## **SUPPLEMENTAL RESPONSE TO REQUEST FOR ADDITIONAL INFORMATION**

### **APR1400 Design Certification**

**Docket No. 52-046**

**RAI No.: 29-7926**  
**SRP Section: 03.02.01 – Seismic Classification**  
**Application Section: 3.2.1**  
**Date of RAI Issue: 06/15/2015**

Figure 9.2.2-1 Component Cooling Water System Flow Diagram (Sheet 2 of 4)

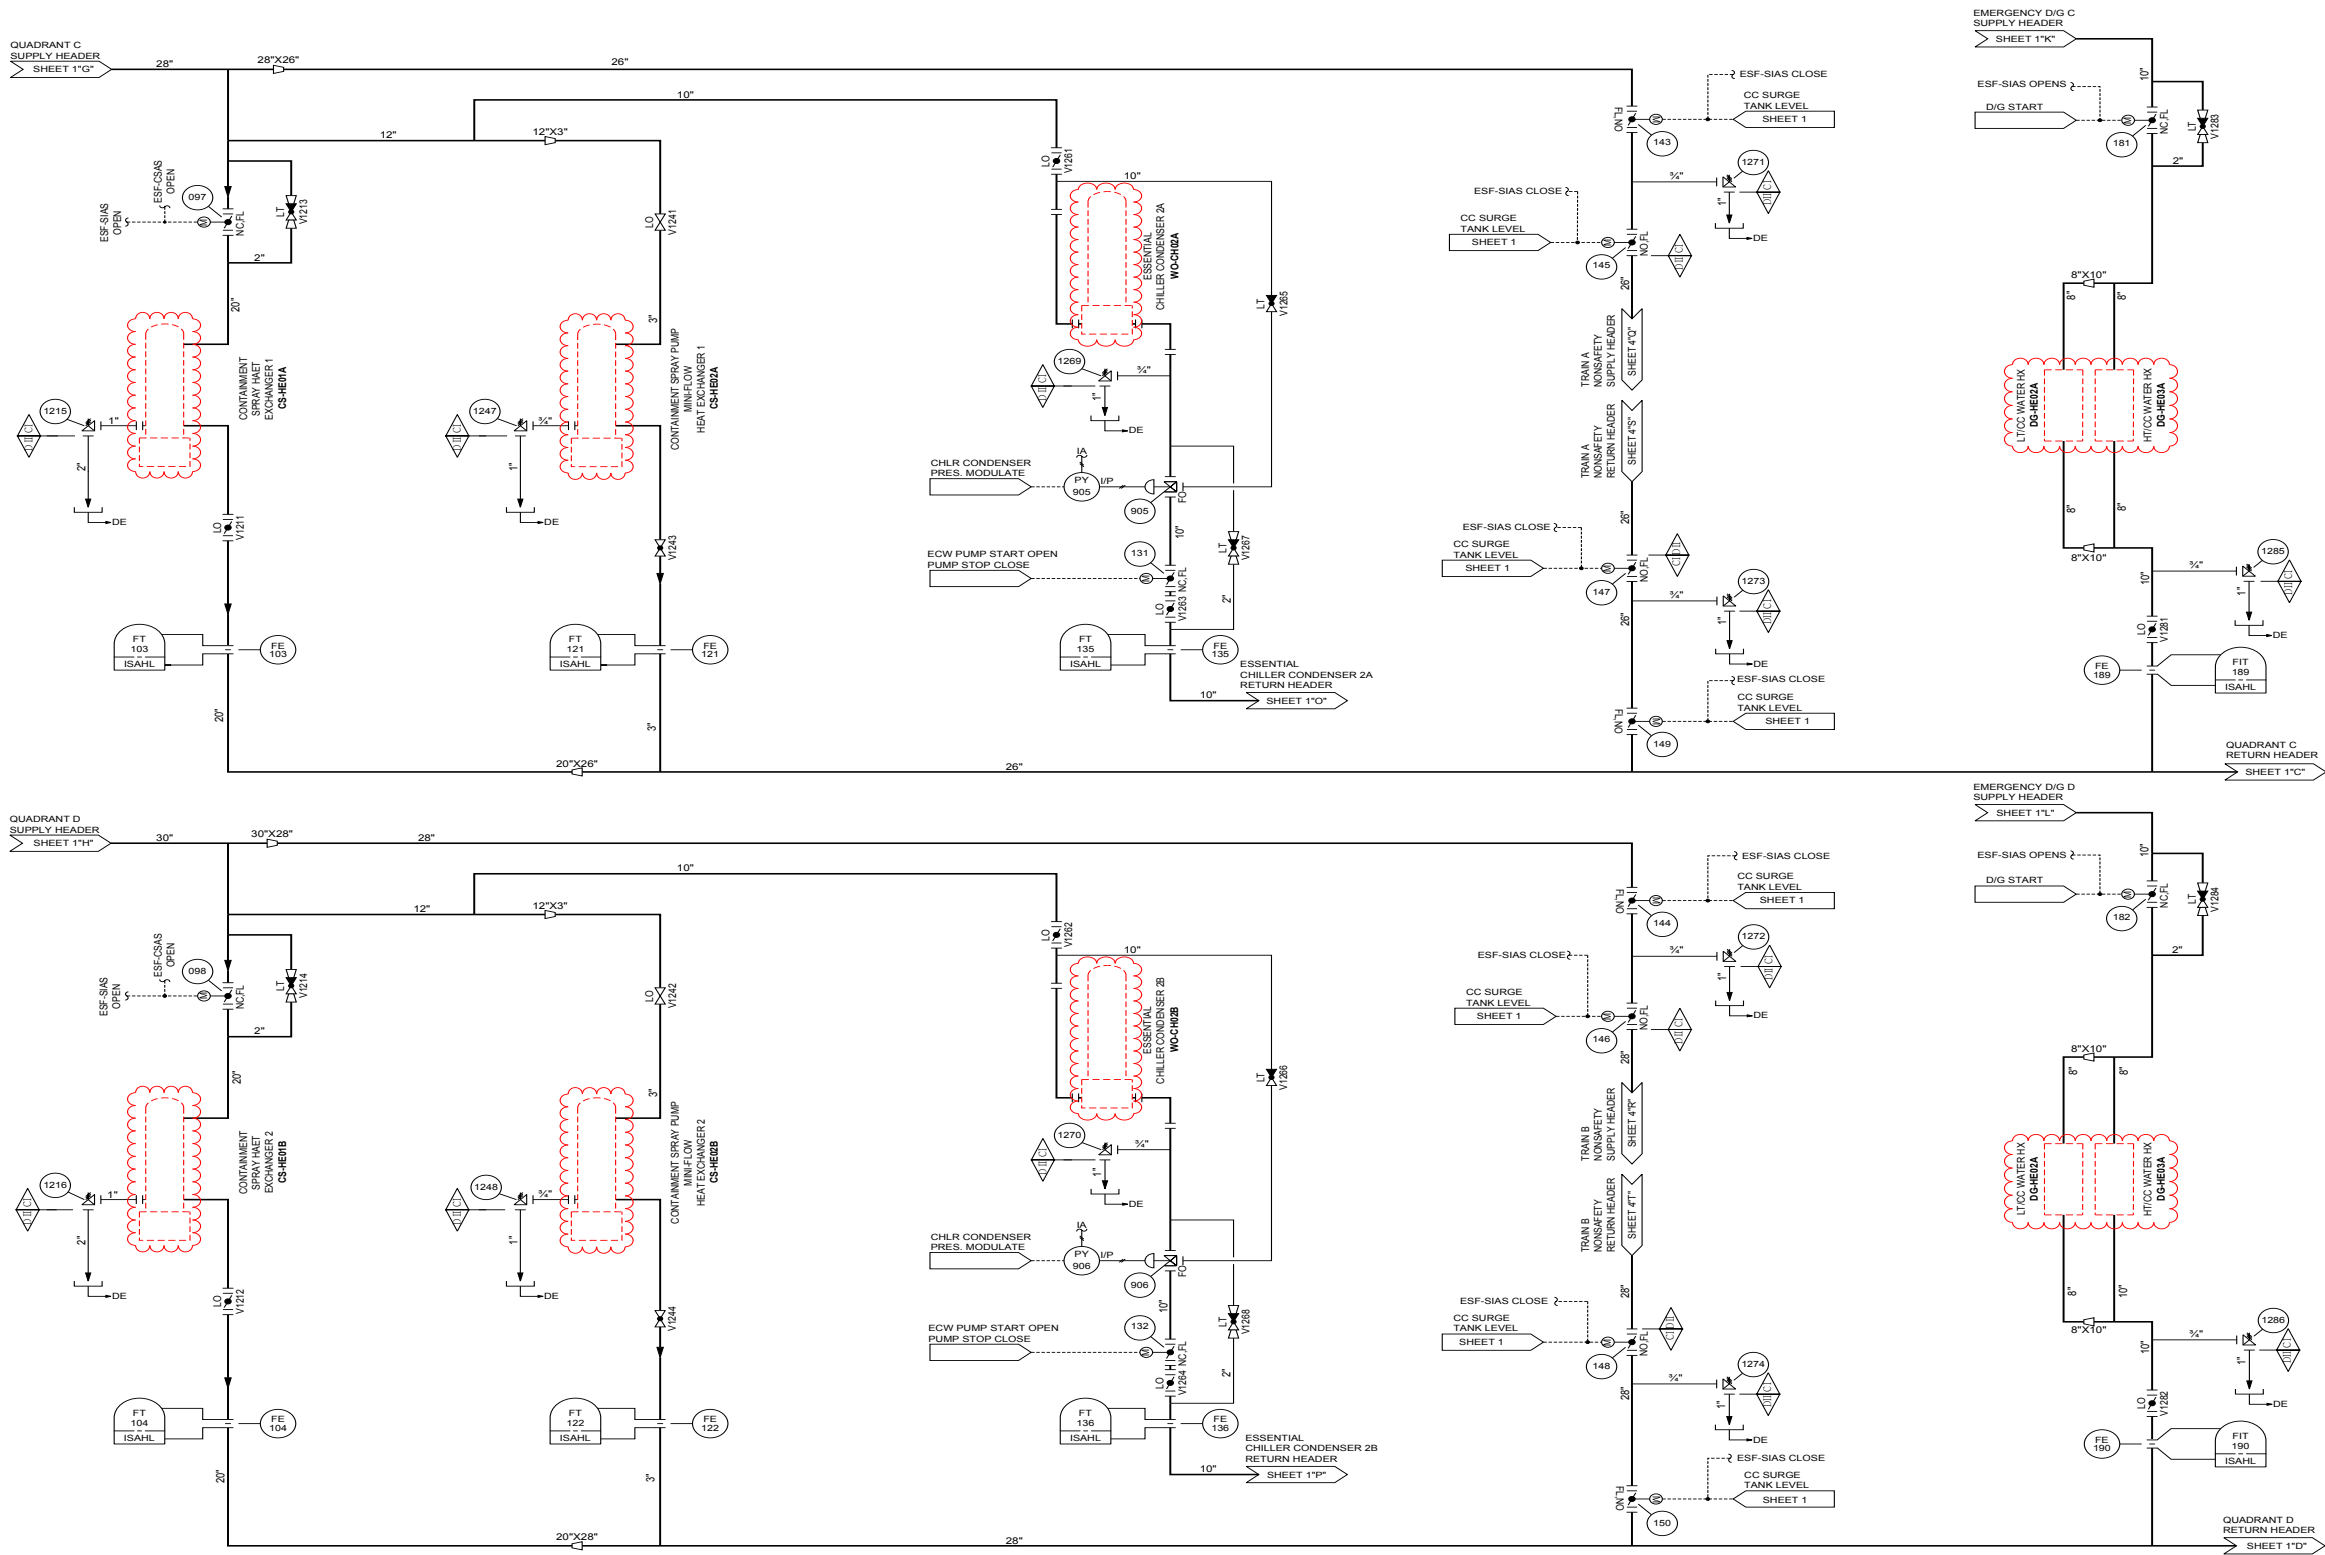
In DCD Tier 2, Table 3.2-1, the letdown heat exchanger supply and return piping between the valves CC-297, CC-301, CC-1685, and CC-1686 in division I, which appears to be part of the component cooling water system (CCW), is identified as seismic Category II, Quality Group D. This is supported in Figure 9.2.2-1 (Page 9.2-149). The letdown heat exchanger itself (part of the chemical and volume control system (CVCS)) is classified as seismic Category I, Quality Group C. This transition is not illustrated in the system figure. Please justify why a portion of CCW, a safety-related system, is not seismic Category I, and why its classification is not consistent with the heat exchanger that it supports. Updates to DCD Tier 2, Table 3.2-1 and associated system figures may be needed to clarify these classifications.

This supplemental response is to clarify the specification difference in the shell (CCW) and tube (CVCS) portions of the letdown heat exchanger and to provide an understanding of the lack of complete piping specification notation on the flow diagrams for the CCW system, Figure 9.2.2-1, of the DCD.

In addition, the flow diagram for the CCWS will be revised for equipment not included in the CCWS to be indicated with dotted lines.

DCD Tier 2 Figure 9.2.2-1 will be revised as indicated in the attached markup.
